POWER PLAN
YOST ELEM. SCHOOL
DUNELAND SCHOOL CORP.
gerometta & kinel architects, inc.

KITCHEN POWER PLAN

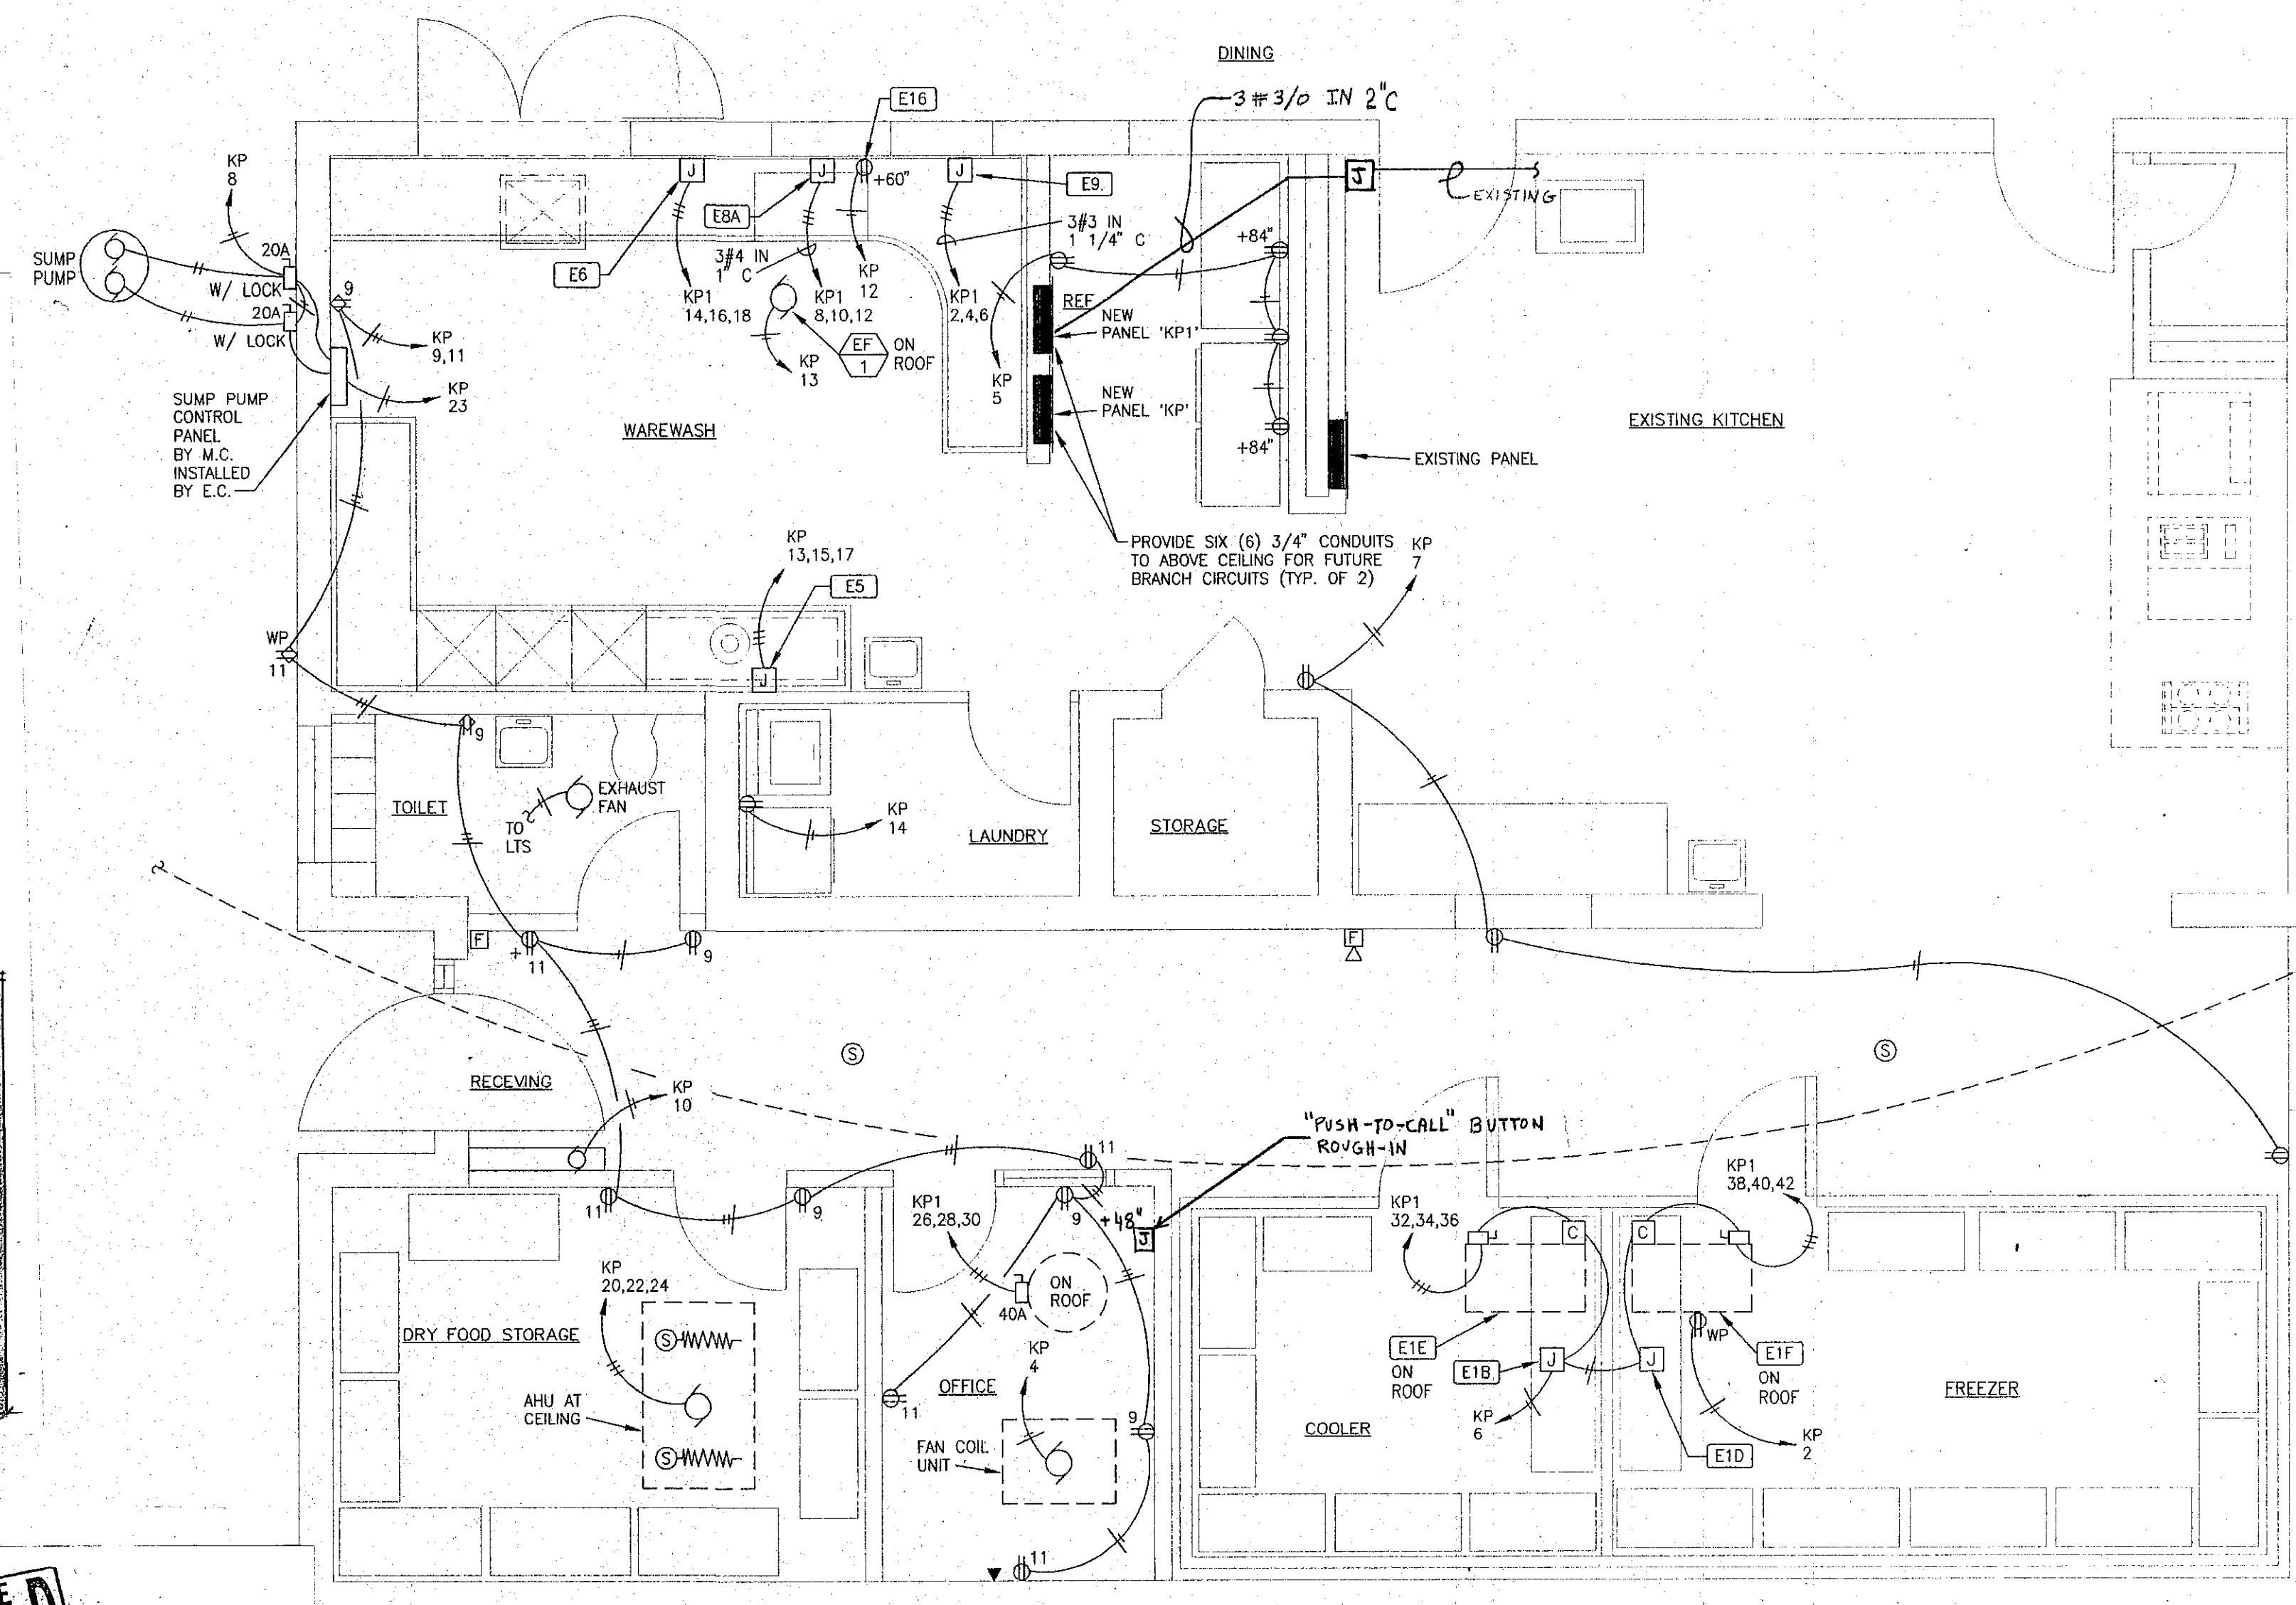
- KITCHEN EQUIP DRAWINGS
IN SPEC SECTION 11400
